ASSESSMENT REPORT – MIXED USE DEVELOPMENT

S79C – Environmental Planning & Assessment Act 1979

DA No:	DA/241/2013
Assessment Officer:	Kate Lafferty
Property:	113-117A Wigram Street, Harris Park & 23-29 Hassall Street, Parramatta Lot Y DP 403345, Lot X DP 403345, Lot B DP 393819, Lot 2 DP 218476, Lot 1 DP126871, Lot 1 DP 218476, Lots 1 & 2 DP 502551, Lot 1 DP126871
Proposal:	Demolition, tree removal and construction of a 22 storey mixed use development containing 156 apartments and 7 commercial units over basement car parking. The application includes the retention of the existing heritage items on site for use as commercial premises.
Cost of works:	\$31,200,000
Date of receipt:	30 April 2013
Applicant:	Hassall Street Property Pty Ltd
Owner:	23-25 Hassall: GLMC Properties Pty Limited 27-29 Hassall: Mistykal Pty Limited 113 Wigram: Mr P Nikoloudis and Mr B Nikoloudis and Mr P Nikoloudis 115 Wigram: Ms K A Schulz and Mr M G Schulz 117 Wigram: Ms I Lambrousis and Mr V Georgoudis

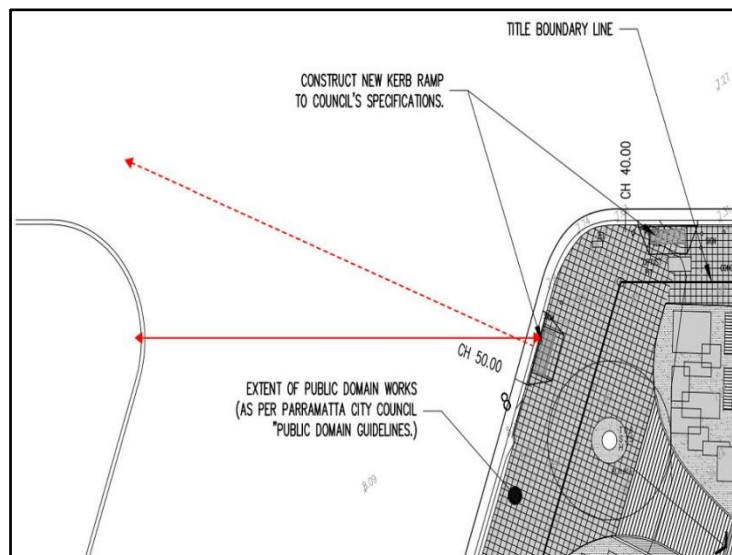
The only change I would like to see is on drawing C01 'Alignments Plan'. The reference to Council's Standard Drawing number DS9 for the footpath crossing on the Hassall Street frontage, should be replaced with "Council's Standard Drawing DS40 v5 Sheet 3".

The alignments plan is still not correct. The kerb ramp in Wigram Street leads pedestrians out into the street dotted line on the attached plan I have drawn on the plan the path of travel solid line which will inform the angle of the ramp.

Planning Comment: The minor variations to the Alignments Plan can be resolved via a condition of consent, which has been incorporated within the Recommendation section of this report.

- (a) Drawing C01 of the Alignments Plan is to be amended. The reference to Council's Standard Drawing number DS9 for the footpath crossing on the Hassall Street frontage, should be replaced with "Council's Standard Drawing DS40 v5 Sheet 3
- (b) The kerb ramp in Wigram Street is to be amended to lead pedestrians directly across the road in Wigram Street.
